BLOCK 41 + BLOCK 44 APARTMENTS

DR HEARING 02 | August 17th, 2017

PEDESTRIAN ACCESS DIAGRAM

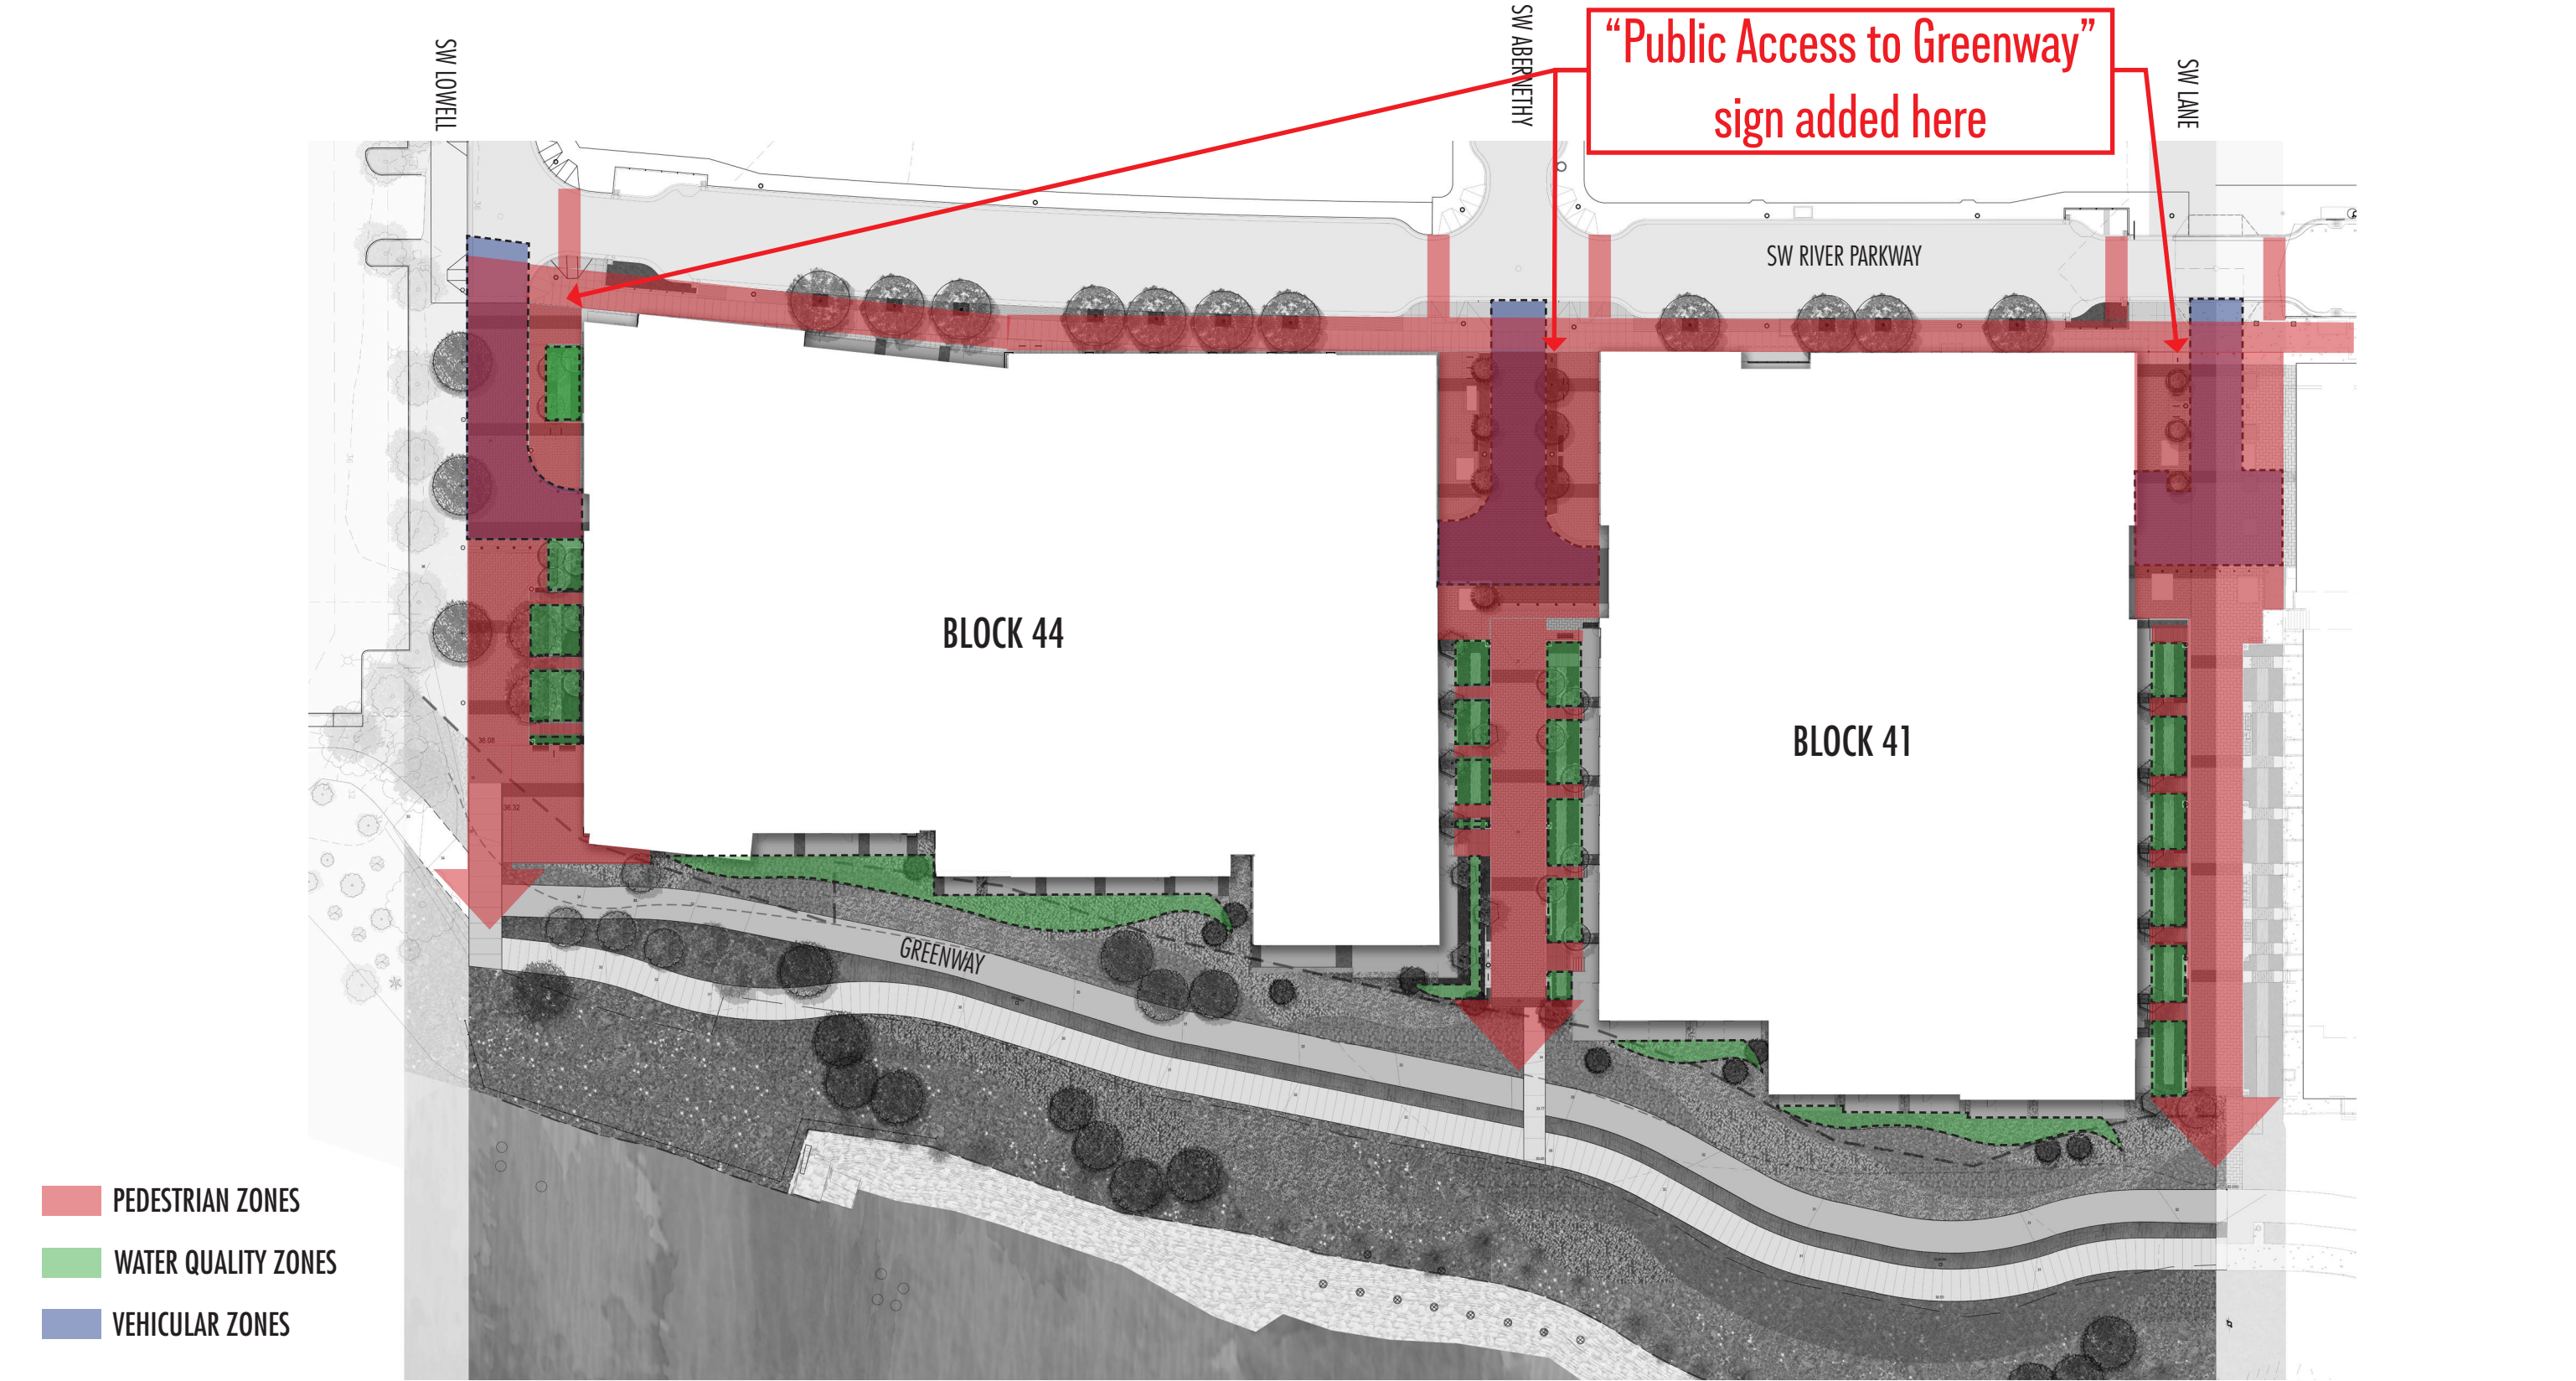
1. Address Paving Pattern and Pedestrian Circulation at Abernethy Street for Pedestrian Safety

2. Add Benches within Pedestrian Accessway on Abernethy

3. Add Signs on Pedestrian Accessways to Indicate Public Access to Willamette Greenway Trail

- Vehicular portion uses darker paving to contract with lighter paving at pedestrian areas. Added more space at crossings.

- Added benches at beginning and terminus of accessway.

- Added signs at west end of pedestrian accessway streets

STORMWATER PLANTER DIAGRAM

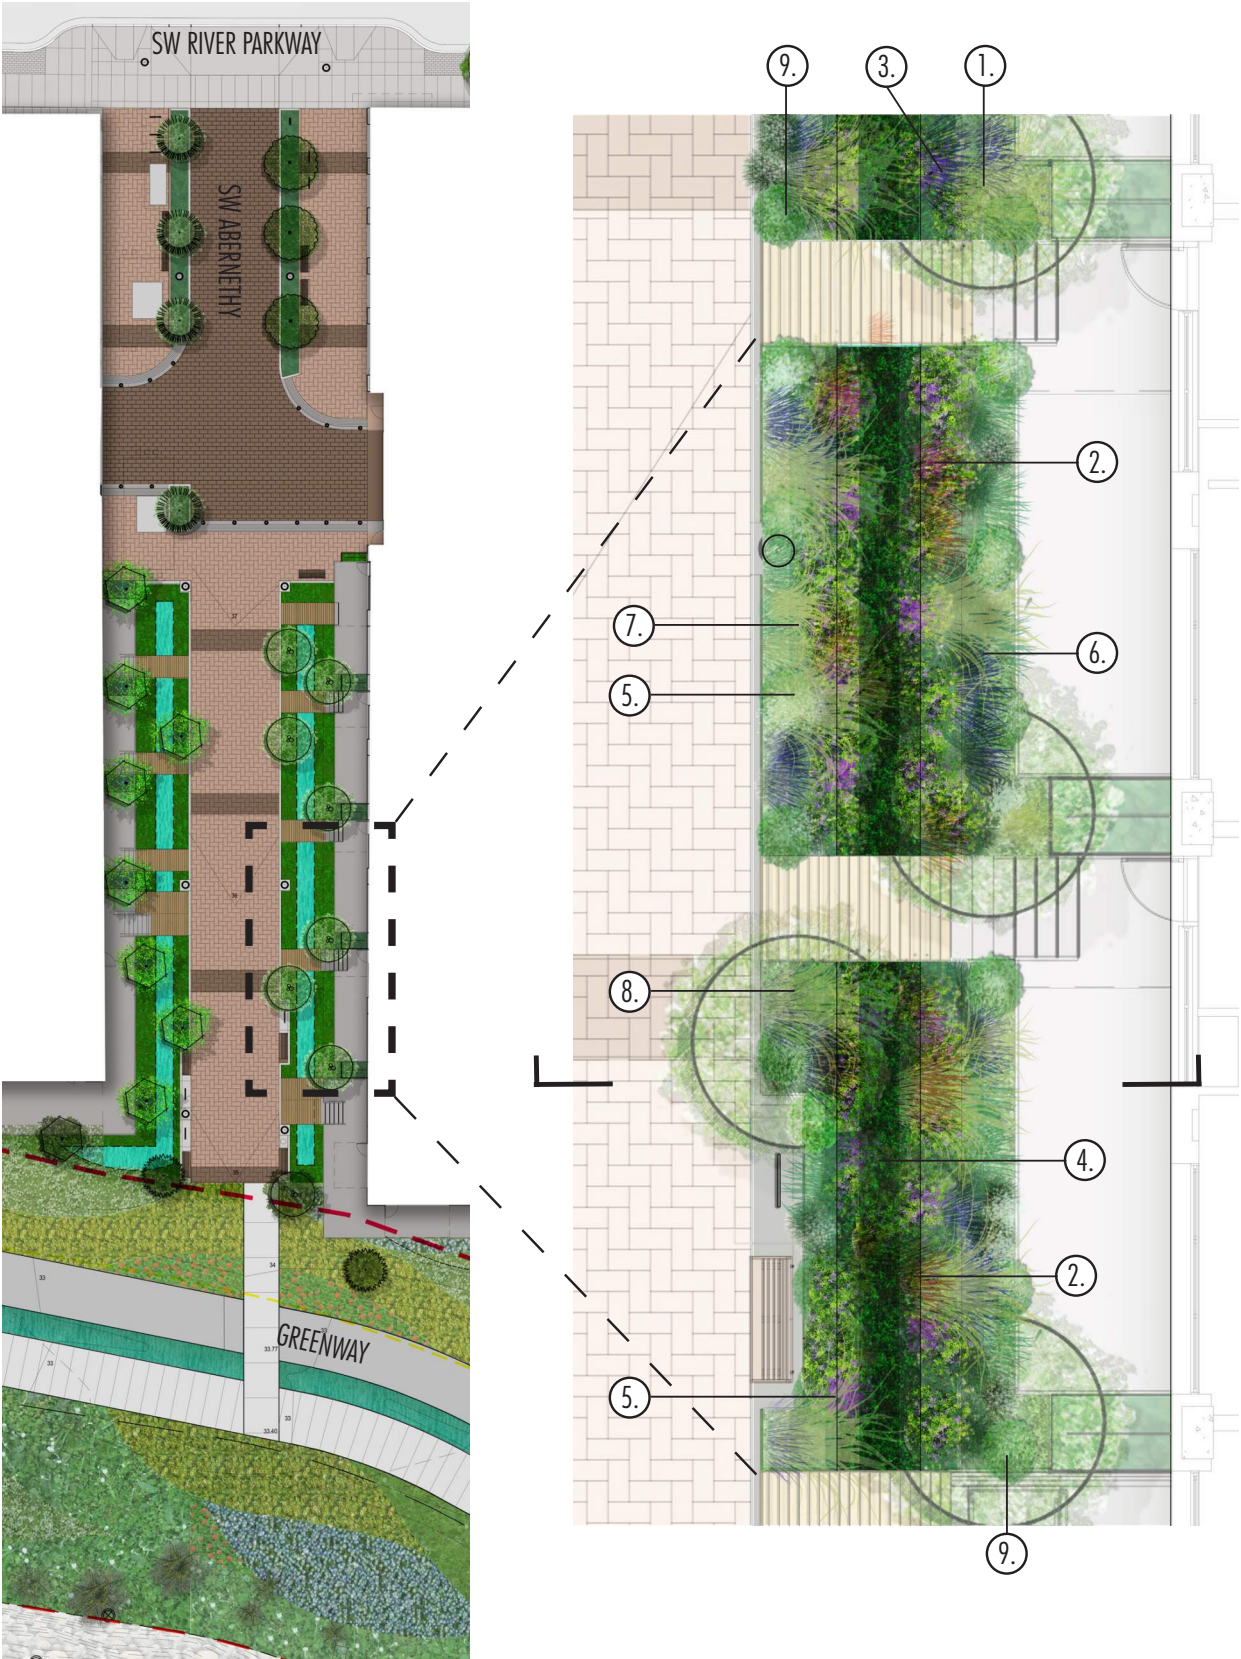
4. Add Gardens along East Side of Buildings in Lieu of Stormwater Planters

5. Add More Garden Like Landscaping Species of Plants in Stormwater Planters

- Added signs at west end of pedestrian accessway streets
4. Add Gardens along East Side of Buildings in Lieu of Stormwater Planters
 - Stormwater diagram has been provided to show extent of stormwater gardens along pedestrian accessways and east greenway.

5. Add More Garden Like Landscaping Species of Plants in Stormwater Planters
 - Stormwater planting plan blow-up and section has been provided to show diversity of species including colorful flowers.

ROOF PLAN

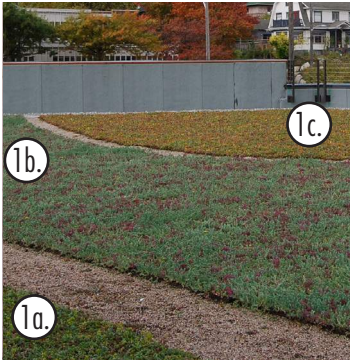
6. Study Upper Roof Treatment on Both Blocks

- Pattern from gardens is added to top most level -creates a pattern as a contrinuation. Combo of light and dark grey to mitigate glare (no longer qualified for LEED point b/c of lower SRI)

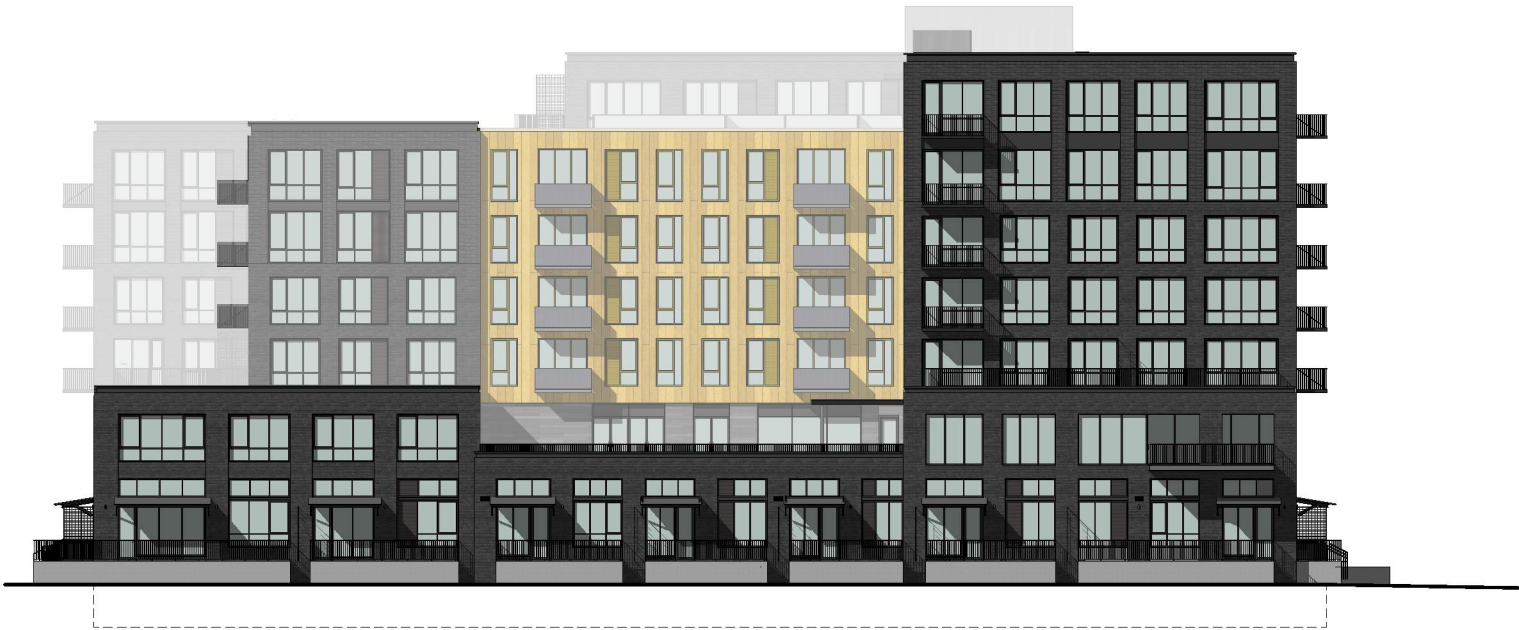
1. Study East Facade - Change Material from Cement Panel to Brick.

- CHANGED CEMBRIT LANGUAGE TO BRICK
- INCREASED GLAZING AT NEW BRICK LOCATION

GROUND FLOOR PLAN

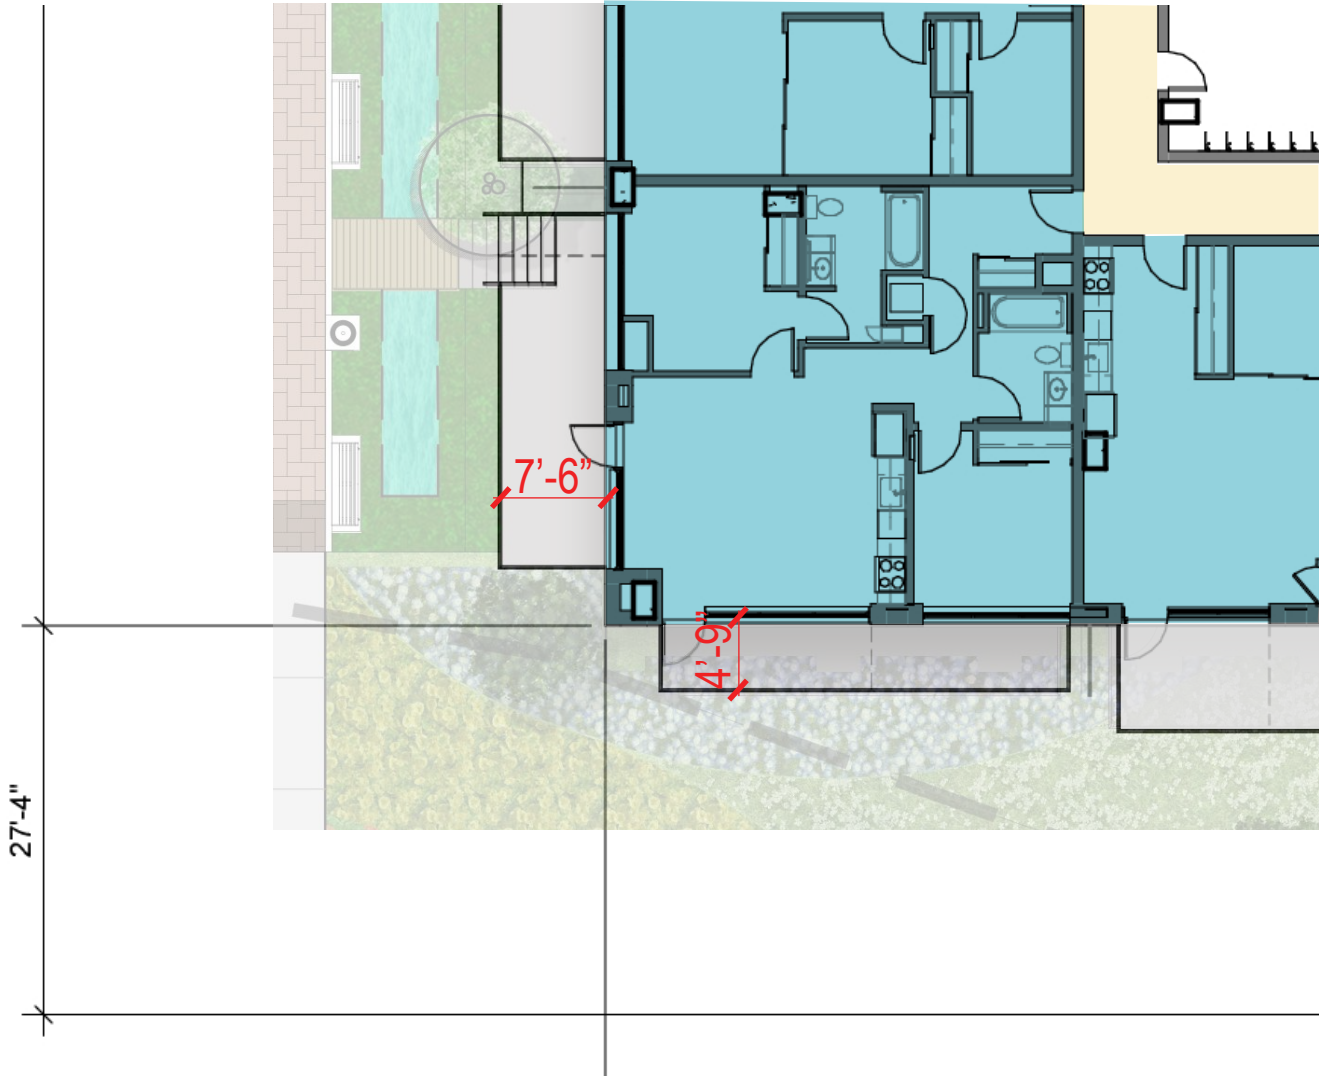
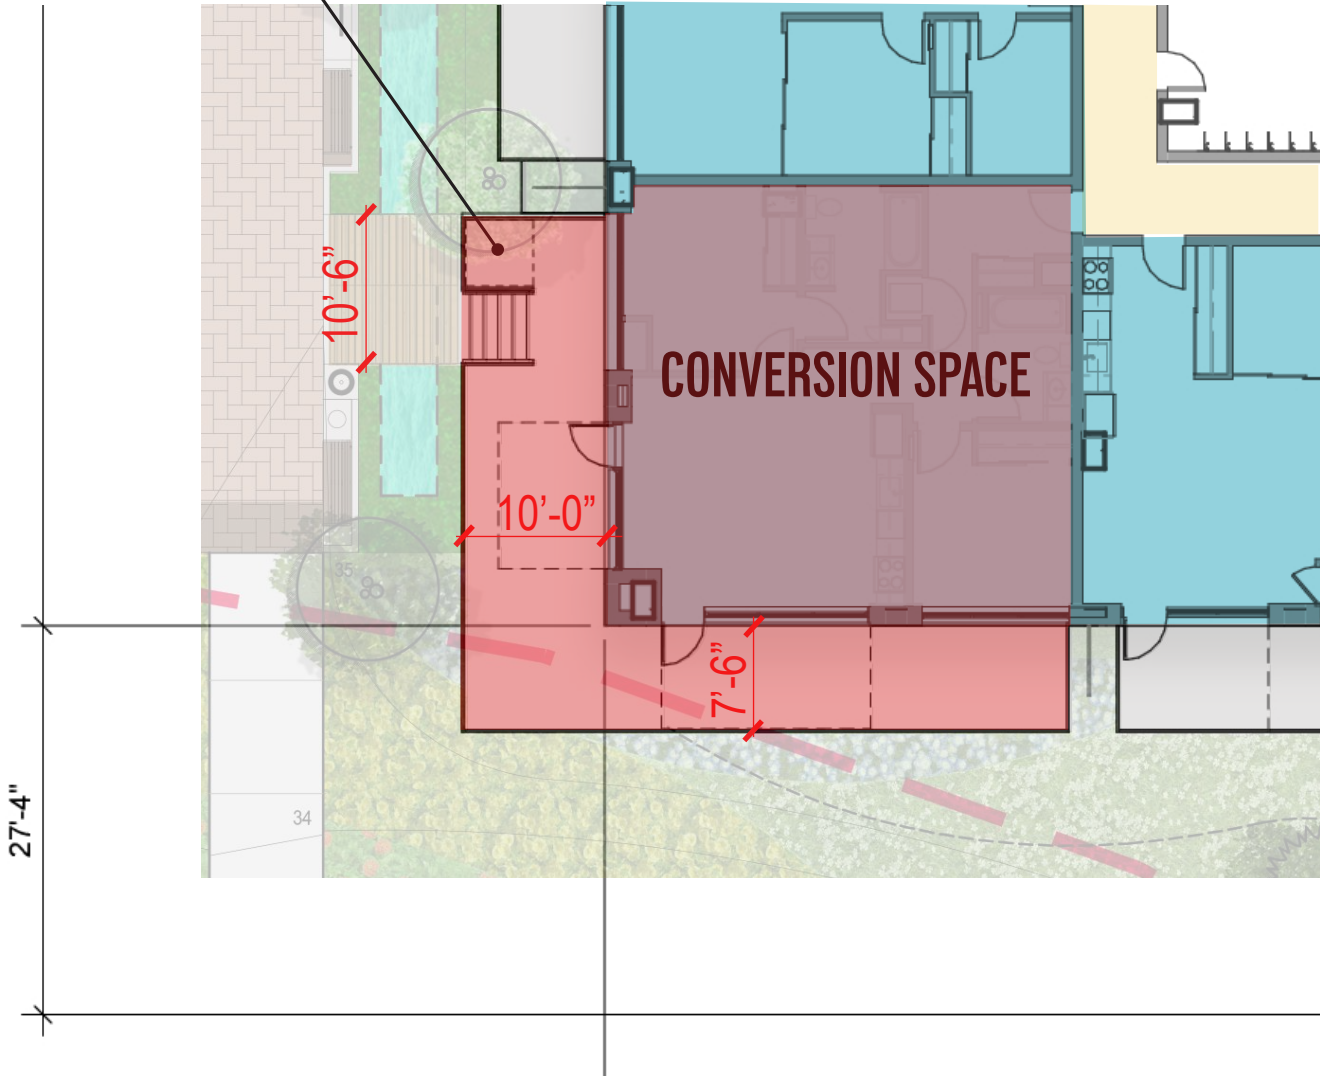
1. Study East Facade - Change Material from Cement Panel to Brick.
2. Study North & West Gasket Condition.
3. Add Full Length Canopy at “Gasket” on River Parkway.
4. Add More Commercial or Conversion Space Along River.
5. Remove Alcove Condition at South Egress Exit Door.

- ENLARGED PORCH AND WRAPPED IT AROUND CORNER
- INCREASED SIZE OF BRIDGE ACCESS
- ADDED FUTURE LOCATION FOR ADA LIFT

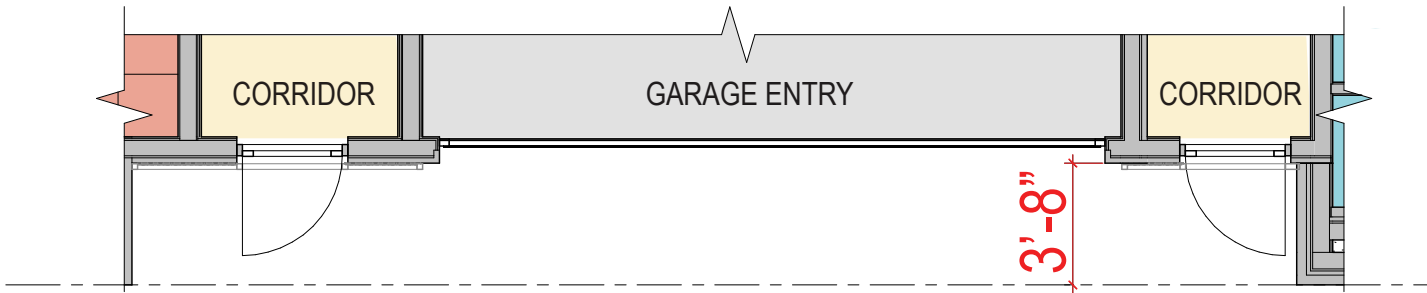
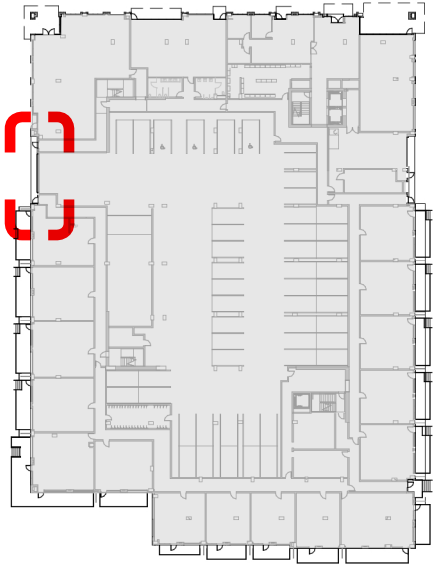
1. Study East Facade - Change Material from Cement Panel to Brick.
2. Study North & West Gasket Condition.
3. Add Full Length Canopy at “Gasket” on River Parkway.
4. Add More Commercial or Conversion Space Along River.
5. Remove Alcove Condition at South Egress Exit Door.

- REMOVED ALCOVE CONDITION.
RELOCATED EXIT DOOR TO SOUTH FACADE.

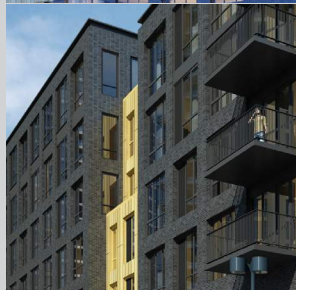
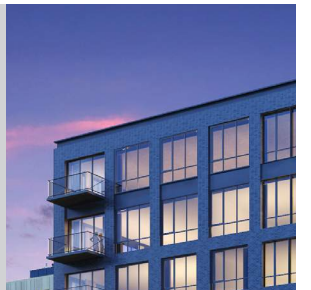
3. Add Full Length Canopy at "Gasket" on River Parkway.

- A Full Length Canopy at the Gasket has been Added
